## MEMO

Job **2013 Site survey Baffin Bay**  
Customer **Shell Greenland A/S**  
Memo no. **1100003404-042-006-3**  
Date **1/07/13**  
To **Shell**  
From **Ditte Marie Mikkelsen**  
Copy to **Claus Fischer Jensen**

**WORK SCOPE CHANGES**

Figure 1 Original site survey (left) as presented in the Preliminary EIA, 1 March 2013 (up to ten sites within the survey areas and three PAM buoys) with locations of Narwhale Protection Zones. Survey with additional sites (right) and five AMAR recorders (replacing the PAM buoys).

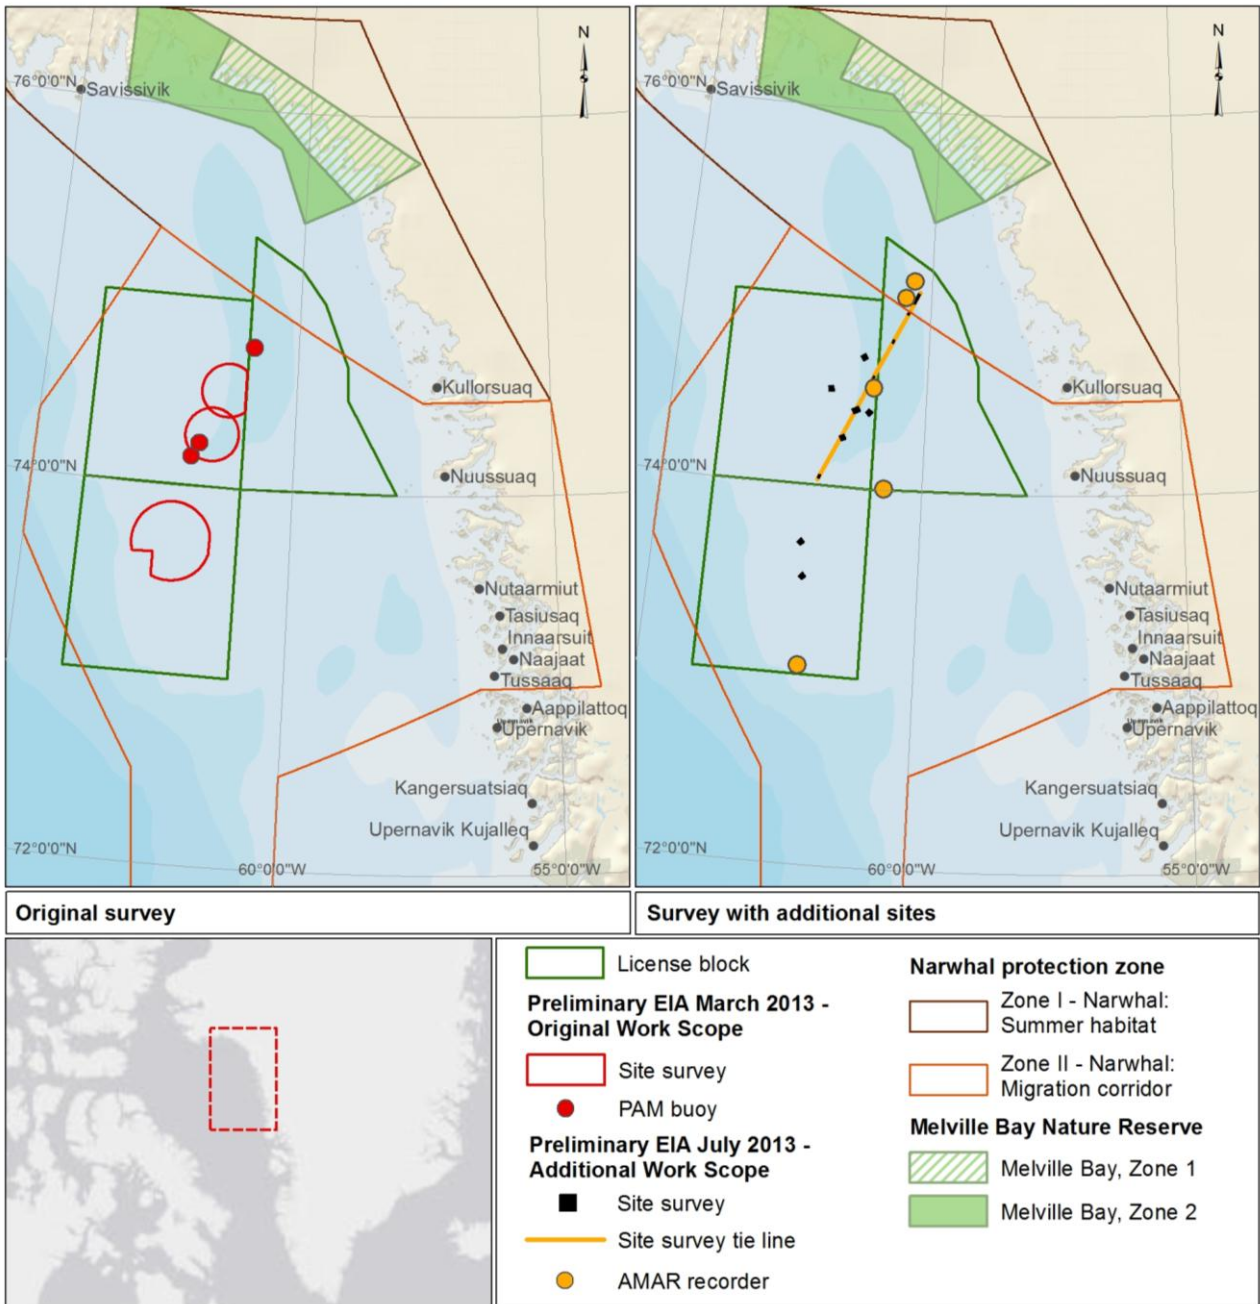
The proposed additional activities of the site survey are described below and presented in Figure 1. Table 2 presents a comparison of preliminary and updated site survey plans.

Three of the survey sites for potential shallow coring locations are in the adjacent block 6 (Pitu), operated by Capricorn. All site surveys in the Pitu block will be terminated before 1<sup>st</sup> October. The north-eastern most survey site is located up to 10 km in the Narwhal Protection Zone I, where the BMP guidelines recommend that “*seismic activities shall be avoided or of limited extent*”. The proposed site survey will be limited to a single airgun array of 140 in<sup>3</sup> where as regular seismic surveys use more guns and with capacities up to 4000 in<sup>3</sup>.

In order to verify the modelling, and as additional baseline data gathering, it is proposed to add two AMAR recorders and place them in the Narwhal Protection Zone I. As well, two recorders would be left over winter to record ambient noise in the Baffin Bay area.
